**SAFETY EVALUATION REPORT**

**REQUEST FOR ALTERNATE DISPOSAL APPROVAL AND  
EXEMPTIONS FOR SPECIFIC HEMATITE DECOMMISSIONING  
PROJECT WASTE AT  
US ECOLOGY'S IDAHO FACILITY**

**April 11, 2013**

**Figure 1: Intruder Scenario Waste Concentration Assumptions**

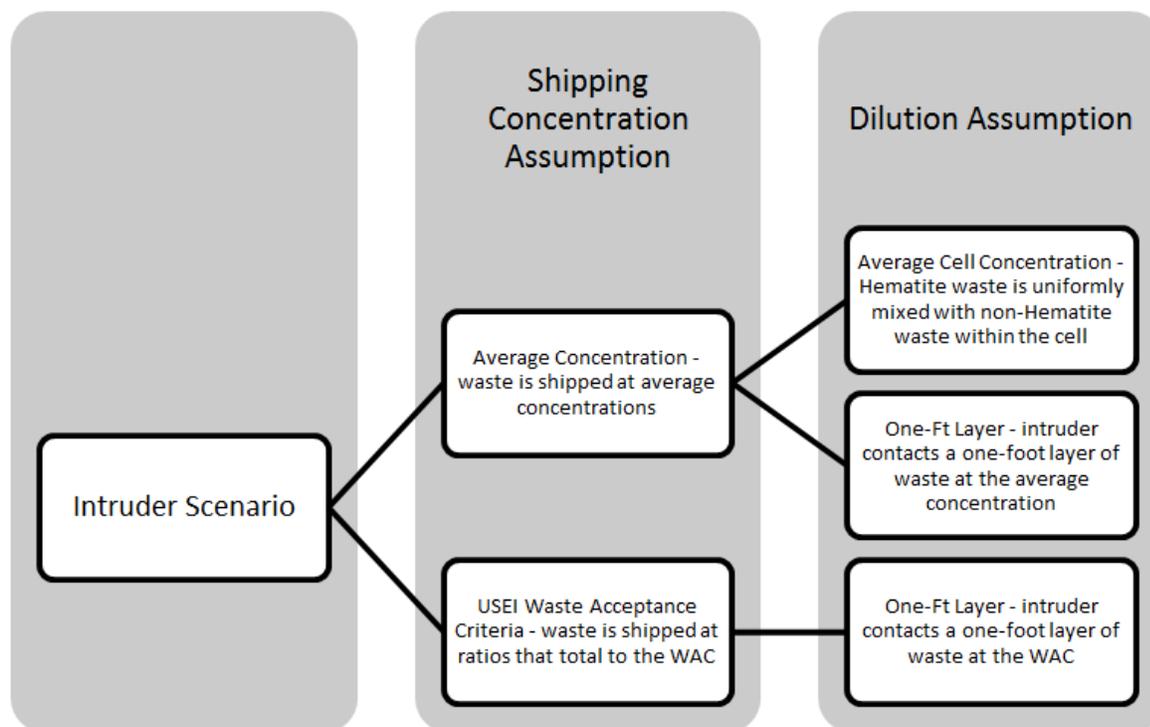
To calculate dose to the intruder post-burial, WEC used the methods from NRC Guidance NUREG/CR 4370, Volume 2 (ADAMS Accession No. ML100250917). WEC performed inadvertent intruder analyses similar to those performed in their March 31, 2010 analysis performed in support of the May 2009 §20.2002 alternate disposal request (ADAMS Accession No. ML100950386). The analyses included variations on assumptions about the concentration of the material as it is shipped and the extent to which the shipping concentrations are diluted once it has been disposed of in the cell as detailed in Figure 3-1. WEC did not evaluate the Average Cell Concentration scenario for material shipped at the WAC for all radionuclides because the volume of material and concentration limits for Tc-99 are such that it would not be

possible for WEC to ship the total volume of waste under this request at the WAC. Instead, WEC did a sensitivity analysis assuming that the total volume was shipped at the WAC containing uranium at values listed in Table 3 2, but not containing Tc-99.
